WORKSHOP AGENDA

Planning Commission

July 15, 2025 @ 5:30 PM

Item #: 3. Site Plan – Smoke Club 13 – New Building of 2,759 Square Feet on 0.42 Acres. Requested by Dean Design Group. Property located at 5234 Murfreesboro Road (Tax Map 15M, Group C, Parcel 6). C-2 (Highway Service) Zoning District. Property owned by Smoke Club 13, LLC. (DEFERRED)

C4.1
UTILITY PLAN

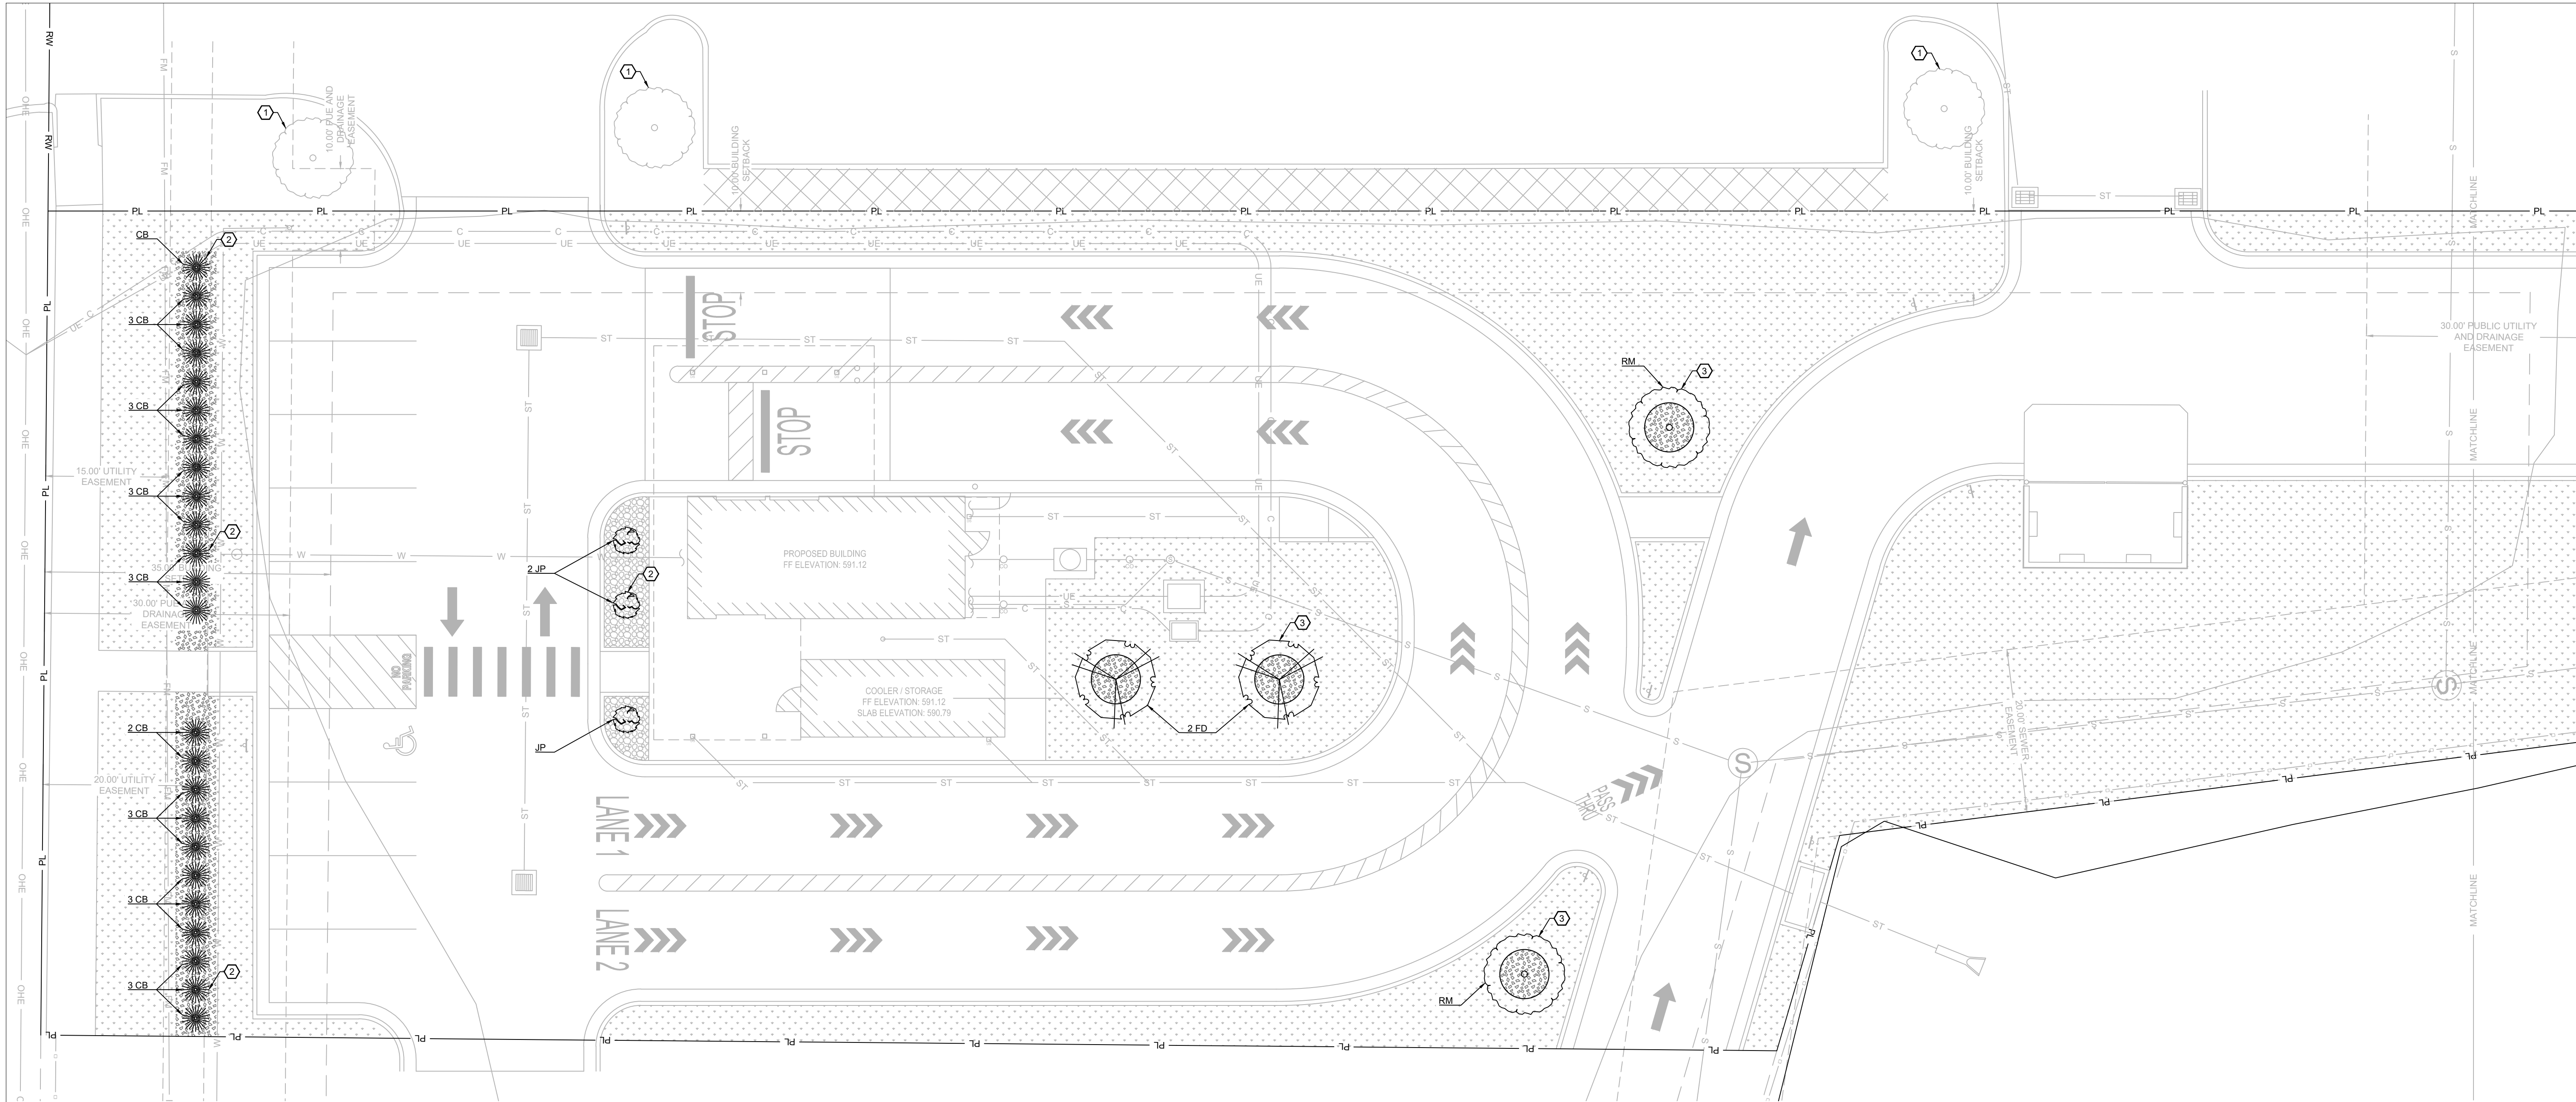
1. (Sheet C4.1) Plan shows pipe #41 and drainage structure #29 being located off of project site and onto Villas of Central Park property as of record in PB 26, PG 78 RORCT. A permanent easement must be recorded for maintenance of this pipe and structure. Staff cannot recommend approval without this easement in place.

9. (Sheet C4.1) Calculations demonstrating that the 8" and 12" diameter corrugated HDPE can handle the 25-year/24-hour storm flows from the developed site must be provided. Head losses from bends and eyes must be included in the calculations.

10. (Sheet C4.1) Calculations must show the amount of surface flow (25-year/24-hour) from the main queuing lanes planned to cross the drive in the north portion of the site before entering curb inlet #32.

11. (Sheet C4.1) Due to the numerous bends and wyes in the storm drainage system and the resultant increased chances of clogging, provide calculations demonstrating that curb inlet #32 can handle the 25-year/24-hour run-off from the entire site assuming that the underground system is clogged.

2. Sht C4.1, show and label existing public sewer service cleanout onsite (located at north end lot approximately 14' south of east/west sewer line, and 17' west of north/south sewer line within the lot).

4. Sht C4.1, route onsite private sewer plumbing at least 5 feet clear of trash bin concrete pad, using one-way cleanouts at angle points.
5. As a point of clarity, the City owns and maintains the public water service from the public mainline through the back of the water meter box. The property owner owns everything thereafter including the backflow preventer. Similarly, the City also owns and maintains the 6-inch public sewer service through the existing public cleanout already installed at the site by the Construction Site Plan for Uptown at La Vergne prepared by Development Services Group (DSG), engineer: Gfranks@dsgva.com. Those plans have elevations and slopes for the installed sewers.
